BULLETIN

Clunking noise from under vehicle

Dodge Dakota and Durango 1997-2004;
Jeep Wrangler 2000-2006

MOOG® K80244 Sway Bar Link

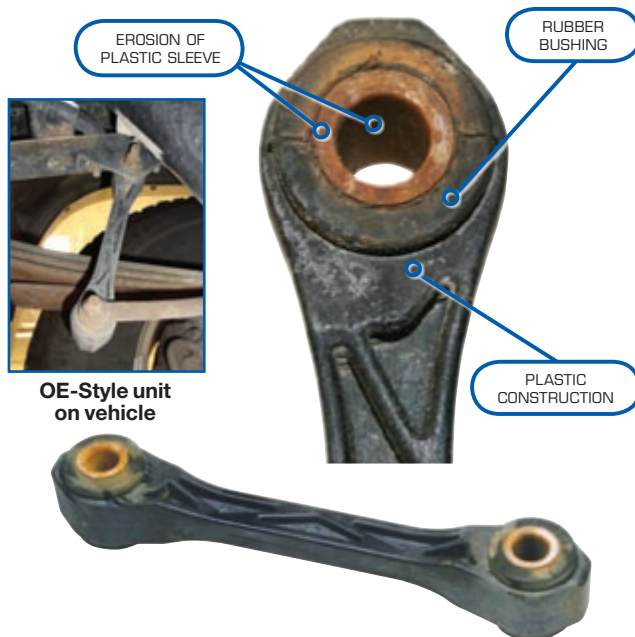
Clunking noise from underneath rear of vehicle

When going over bumps or washboard surfaces, drivers of Jeep Wranglers, Dodge Dakotas and Dodge Durangos may experience clunking and/or banging noise from underneath the rear of the vehicle. The cause is failure of the rear sway bar link. The OE-style link is prone to failure on these vehicles, especially in northern climates where more salt, road grit and grime are present. These contaminants can get into the bushing and erode the plastic sleeve, causing it to elongate and become loose, which creates noise.

The MOOG K80244 Sway Bar Link was designed for ease of installation and long life.

- Phosphate-coated, all metal design improves strength and durability.
- Thermoplastic bushings reduce noise, add strength and resist wear, salt, road grit and grime better than typical rubber bushings. In addition, they are less prone to splitting.
